Our 41st. Competition

Won By G. W. HAINES ("XXX,") Christchurch

Only two designs were sent in for this competition viz.:—"April Morn" by N. Wallnutt with Messrs. Mahoney & Son, Auckland, and "XXX" by G. W. Haines with Mr. J. S. Guthrie, of Christchurch. The judge, Mr. Wm. H. Dunning of Dunedin reports as follows:—

Winning design "XXX," by G. W. Haines with Mr. J. S. Guthrie of Christchurch

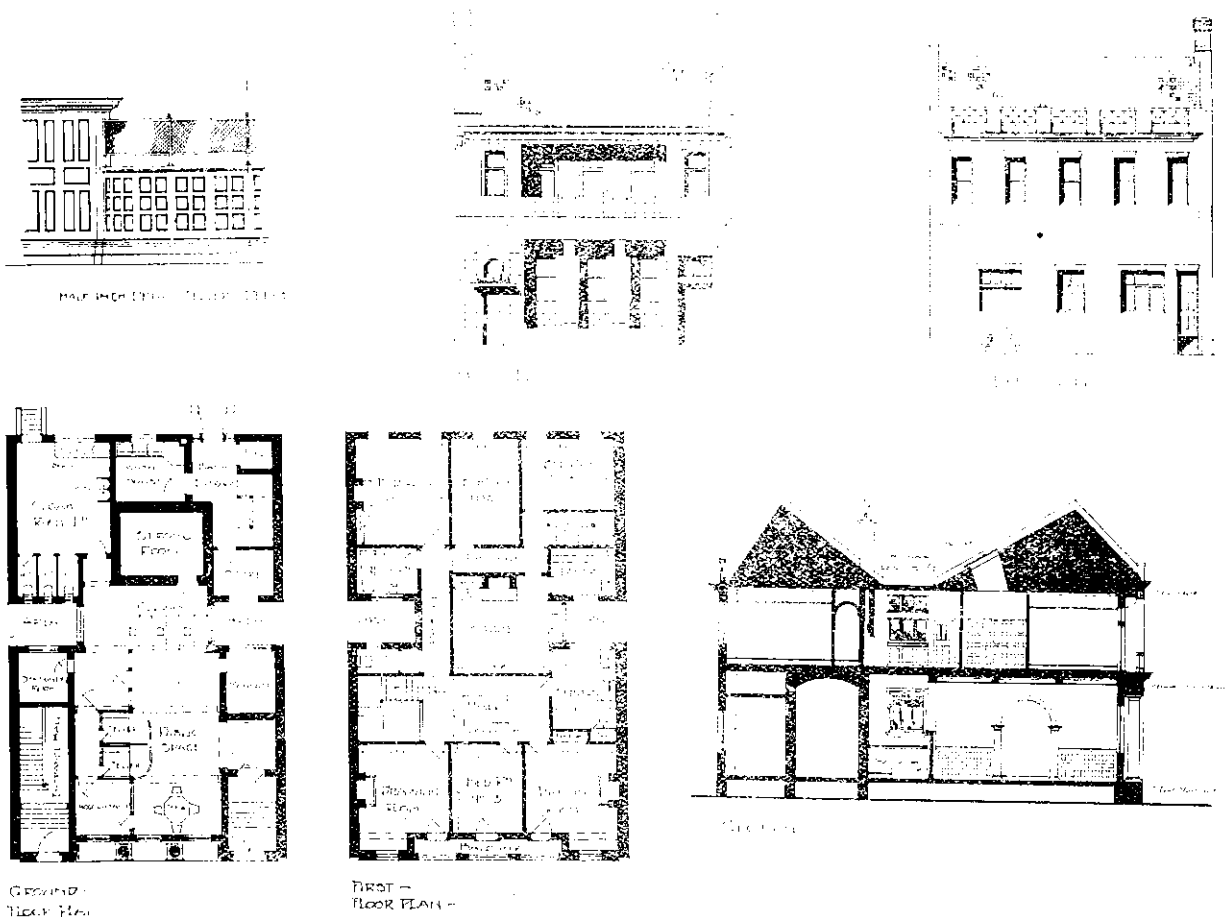
etc. Enough attention has not been given to lighting, the light areas being far too small. By extending them it would have made the strong room, cloak room and back entrance in better proportion and have given the necessary light. The first floor is well arranged with the exception that the passage leading across area is badly lighted, but could be easily overcome. The elevations are well drawn though somewhat domestic in treatment. It is a pity a little more of the half-inch detail of fittings was not shown, also more attention paid to the drawing of these.

"XXX" has shown a good deal of originality in his planning, but has failed to grasp the problem in many points. The Banking Chamber is well arranged, but the Manager's room is far too small and would require access to the staff, as having to cross the public space is not desirable. This could have been obtained by making the side wall in the shape of a bay carried out in wood to harmonize with the fittings; the other side of entrance being treated in a similar way and fitted with a table for writing cheques
